Community Planning and Preservation Commission Certificate of Appropriateness Request

AGENDA ITEM:	CITY FILE NO.: 20-90200120
REQUEST:	Review of a Certificate of Appropriateness for the rehabilitation of historic buildings and structures at Sunken Gardens, an individually listed landmark of the St. Petersburg Register of Historic Places (98-03)
OWNERS:	City of St. Petersburg
PARCEL ID NO.:	18-31-17-86581-001-0010
ADDRESS:	1951 4 th St. N. (aka 1825 4 th St. N.)
LEGAL DESCRIPTION:	SUNKEN GARDENS BLK 1, LOT 1
ZONING:	CCT-1

Case No. 20-90200120 CPPC January 12, 2021 pg. 9

Figure 7: Image from within site showing several generations of paving techniques abutting

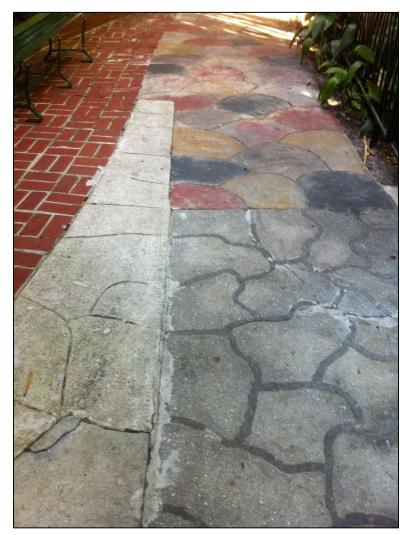
This variation provides an interesting portrayal of the site's continuing expansion and evolution. It also, however, creates ADA compliance and design challenges when alterations are necessary.

Perhaps it would seem that the simplest and most visually seamless approach would be to remove all historic pathways in areas of rehabilitation and replace them with contemporary concrete. However, as a designed landscape, the manmade pathways through Sunken Gardens, and the routes of circulation through the exhibits that they facilitate, are among the most fundamental of the landmark's resources. In no small part, the paths define the experience of visiting the site. The existing patchwork brings attention to its generations-long development and provide an opportunity for interpretation of the several periods that shaped the site.

Figure 10: Demolition plan for walkways and Orchid Garden

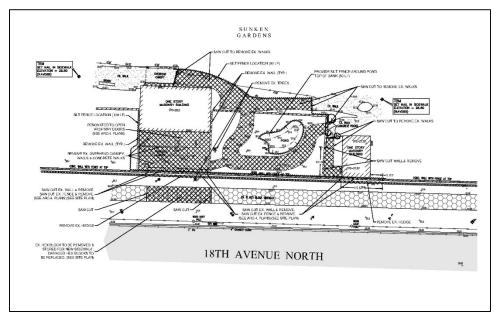
In the case of the proposed project, the applicant proposes the removal of pathways and paved areas adjacent to the Entrance Building in order to address drainage issues. These walkways, as well as additional patio space surrounding the Entrance Building, are proposed to be paved

Figure 11: Proposed paving with hierarchy created by retaining multicolored pattern along primary walkway, as recommended by staff.

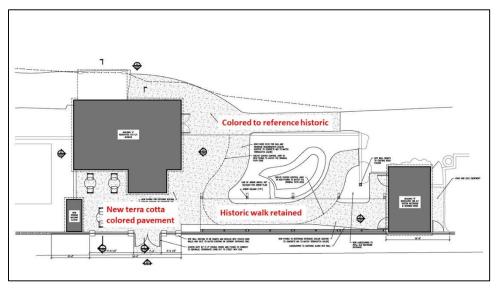
Staff recommends the walkways be differentiated to distinguish the coloring at the main circulation walk from the Orchid Garden/patio space and retain the restored historic path around the Orchid Garden pond as shown above. This is in keeping with the Cultural Landscape Report's recommendations and staff agrees that it is a good approach to distinguish the new patio/plaza space from the original, vegetated garden.

As seen in the historic postcard on the cover of this report, the Entrance Building is historically depicted to have been rather tightly surrounded by lush plantings. Paving much of the Orchid Garden and space between the Entrance Building and Site Wall for outdoor dining space will diminish this effect. However, when considering the goal of increasing the building's use and adding historic interpretation to the site, staff considers it appropriate as part of the overall rehabilitation of this section of Sunken Gardens.

- 3. New pavement surrounding the Entrance Building and Orchid Garden will feature a terra cotta "fish scale" pattern to provide differentiation from the historic path.
